CDM: Response form for request for clarification on Approved Methodologies (version 01.1)
Date of Meth Panel meeting:	19 - 23 January 2009
Title and number of request for clarification	Guidance on continued applicability of methodologies in relation to changes in project plans for a registered project AM_CLA_0129
Summary of the query: Please use the space below to summarize the request for clarification on the related approved methodologies.	
<p>This request for clarification refers to the response of request for clarification AM_CLA_0080 in which guidance was sought on the continued applicability of the methodologies AM0025 Version 05, ACM0001 Version 04 and AMS-I.D Version 09 in relation to the P.T. Navigat Organic Energy Indonesia Integrated Solid Waste Management (GALFAD) Project in Bali, Indonesia (the “Project”), which was registered on 20 May 2007.</p> <p>This request for clarification deals with two issues:</p> <ol style="list-style-type: none"> 1. Change in project plans from the registered CDM-PDD. 2. Change in monitoring plans. <p>The project proponent wishes to provide more information in line with the points raised by Meth Panel:</p> <p><u>1. Change in project plans fr

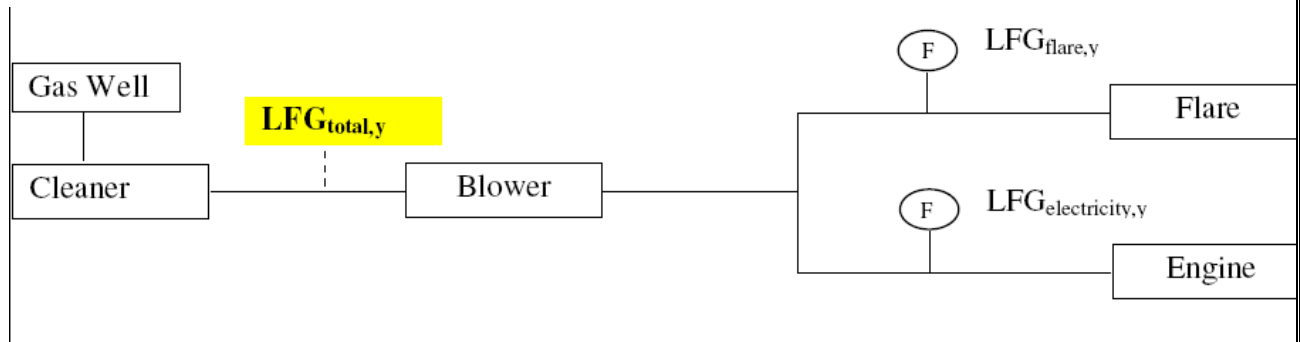
(a) Meth Panel response re monitoring of LFG generated: “The Panel in its earlier clarification (AM_CLA_20) stated the redundancy of metering is to ensure conservative estimation of emission reductions. Therefore, the PPs should measure gas flow at the generation and collection point, which could be located after the cleaning device, and also at all the source of destruction of LFG (flare and energy equipments)”

PP Response: The PP would like to thank the Meth Panel for its guidance. As per the guidance, additional equipment $LFG_{total,y}$ as highlighted in the below diagram will be installed.
